AUGUSTINE CUT OFF MULTIMODAL IMPROVEMENTS STUDY, PHASE 2

Advisory Committee Meeting 4
September 4, 2025

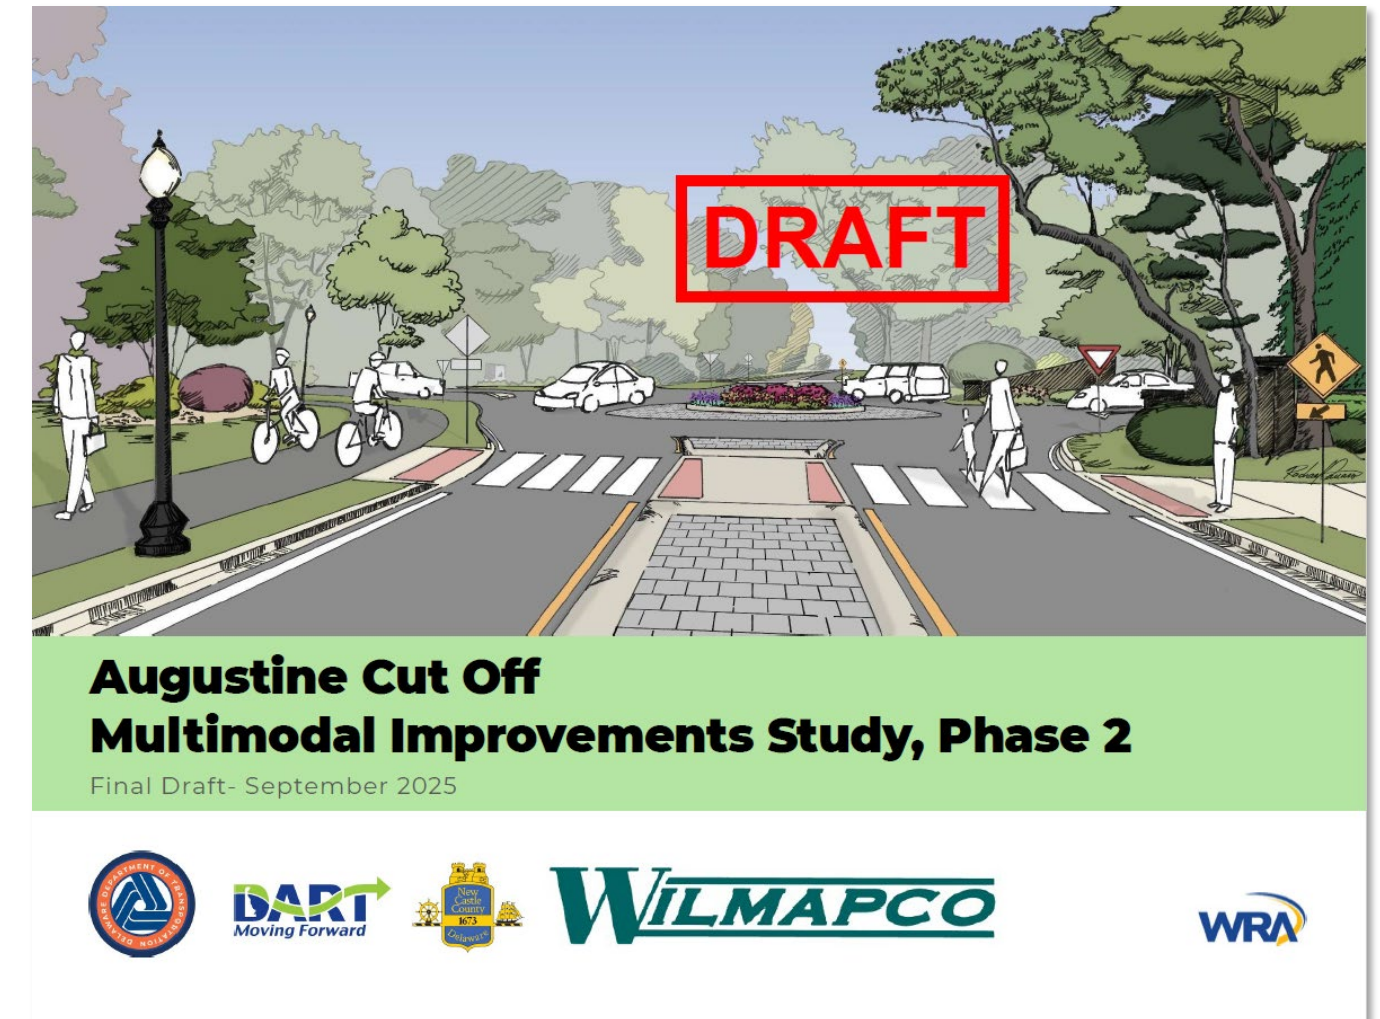
- ***Concern:** Homes between Stone Hill and Cantera Road won't have room to park on ACO*
- ***Response:** all alternatives retain on street parking for this section of ACO*
